PLANNING DIVISION STAFF REPORT

Project Address: 4417 Hillcrest Drive (11th Aldermanic District, Alder Martin)
Application Type: Demolition Permit
Legistar File ID # [60165](#)
Prepared By: Chris Wells, Planning Division
Report Includes Comments from other City Agencies, as noted
Reviewed By: Kevin Firchow, AICP, Principal Planner

Requested Action: The applicant requests approval of a demolition permit to raze the existing single-family home and construct a new single-family residence in the TR-C1 (Traditional Residential – Consistent 1) zoning district at 4417 Hillcrest Drive.

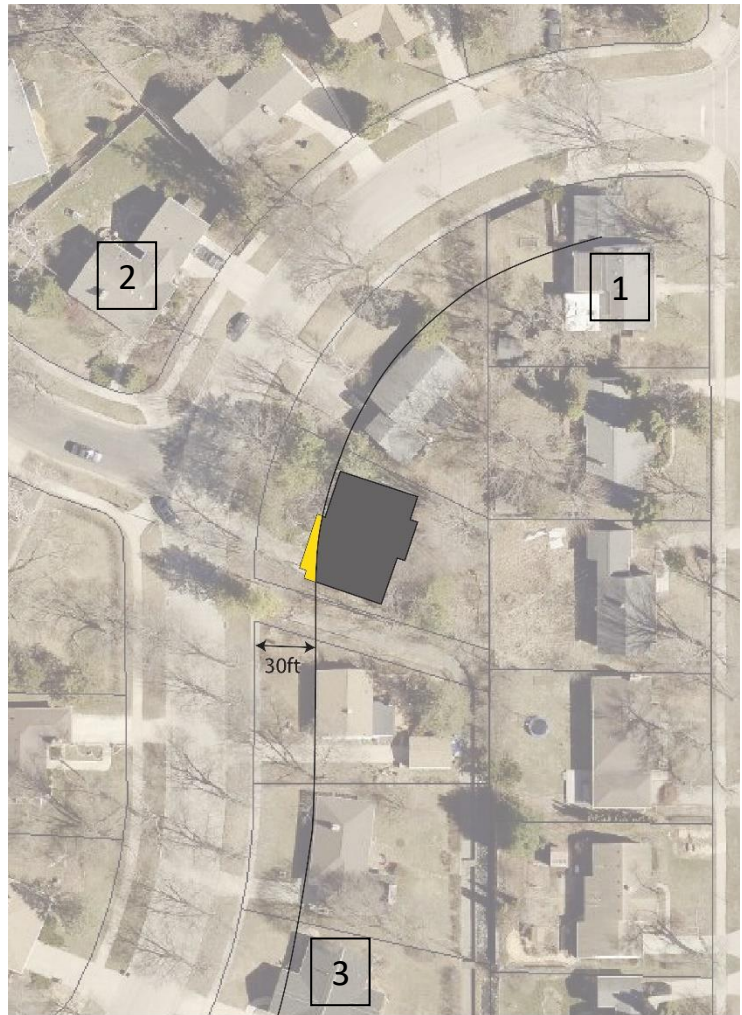
Finally, while Staff believe the proposal is consistent with the [Hoyt Park Area Neighborhood Plan's](#) (2014) recommendation of Low-Density Residential uses. Staff believe careful consideration should be given regarding the Plan's specific residential design guidelines. On Page 56, the Plan includes residential design guidelines that pertain to such things as the orientation, articulation, and front yard landscaping of residences. Of note, regarding building orientation, it notes the following consideration: “*Position the house at or near the front setback line and in line with adjoining homes.*” While the majority of other residences located along this block of Hillcrest Drive are set roughly 30 feet back from the front property line, the proposed house is set back roughly 21 feet, at its closest point. The garage is set back approximately 33 feet. Please see the image to right, with the area of the footprint located within the recommended setback colored yellow.

Staff do note that there are other notable exceptions to the 30-foot typical setback located in the immediate vicinity, such as the adjacent house to the north of the subject lot (set less than seven feet back along Hillcrest) (noted as #1 in the image to the right), the house to the northwest across Hillcrest, on a reverse corner lot (set roughly 13 feet back along Hillcrest Drive) (noted as #2), and the third house to the south (set roughly 25 feet back) (noted as #3).

Based on these nearby exceptions, the location on a curve, the additional right-of-way to the south, and the recognition that roughly half of the front façade is consistent with prevailing 30 foot setback, Staff believe that it may be possible to find that the proposal is compatible with the [Hoyt Park Area Neighborhood Plan](#).
